U.S. NUCLEAR REGULATORY COMMISSION
AUDIT SUMMARY FOR THE REGULATORY AUDIT
OF NUSCALE POWER, LLC DESIGN CERTIFICATION APPLICATION CHAPTER 4,
“REACTOR”; CHAPTER 5, “REACTOR COOLANT AND CONNECTING SYSTEMS”; AND
CHAPTER 9, “AUXILIARY SYSTEMS”

Figure 2. SIMULATE5 Radial Reflector Region Diagram

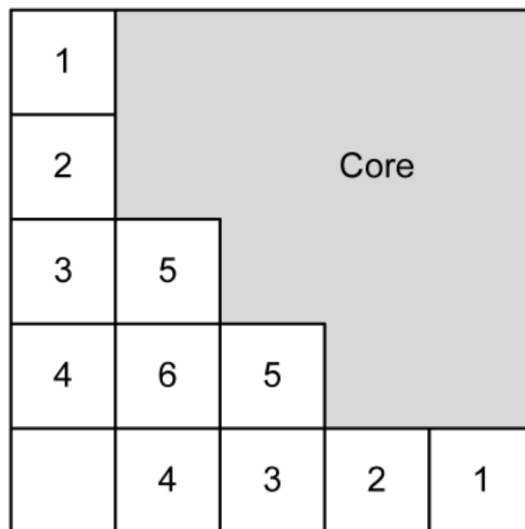
The NRC staff requested the NuScale clarify the neutronic modeling of the radial reflector region. NuScale provided the following explanation:

- The modeling of the radial reflector in the NuScale RXC is split into multiple segments matching the square array and pitch of the fuel assemblies. The radial reflector segments are identified according to their position around the core and the relative material composition of the segment, as shown in Figure 3-5 of the TR-0616-48793, "Nuclear Analysis Codes and Methods Qualification Topical Report," (provided below as Figure 2 for completeness). [
